BEFORE THE ILLINOIS POLLUTION CONTROL BOARD

IN THE MATTER OF:)
)
 PETITION OF ROYAL FIBERGLASS)
 POOLS, INC. FOR AN ADJUSTED) AS 09-4
 STANDARD FROM 35 ILL. ADM. CODE) (Adjusted Standard - Air)
 215.301

**RESPONSES OF PETITIONER ROYAL FIBERGLASS POOLS TO QUESTIONS
 FROM THE ILLINOIS POLLUTION CONTROL BOARD**

Maps showing the location of the Dix Plant were included in Exhibit 1 of the First Amended Petition. Also attached hereto are an additional map and aerial photograph labeled **Exhibit A** and **Exhibit B**, respectively.

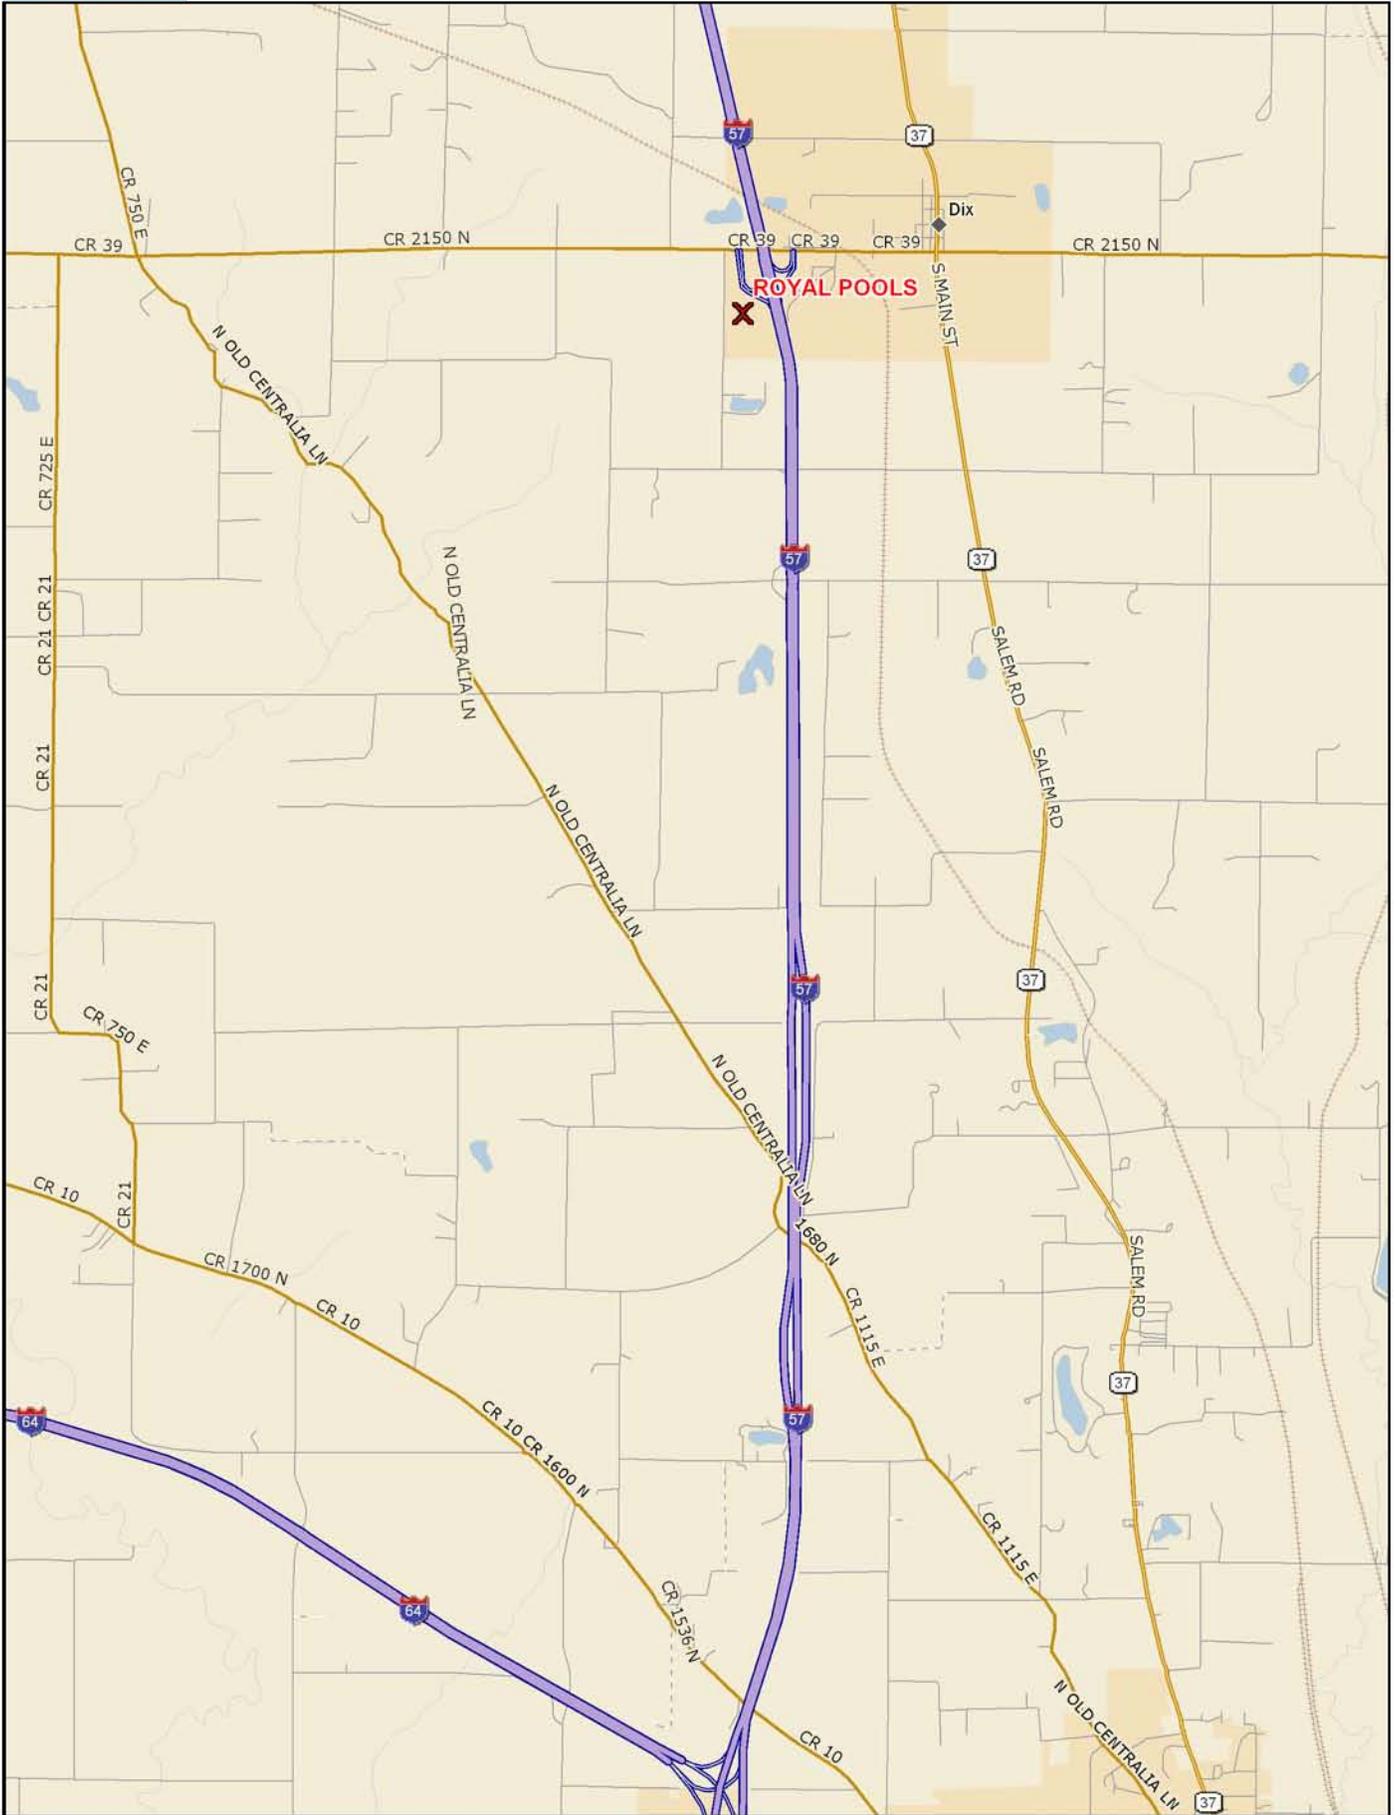
3. Would you please provide a map indicating the location of the Dix Plant?
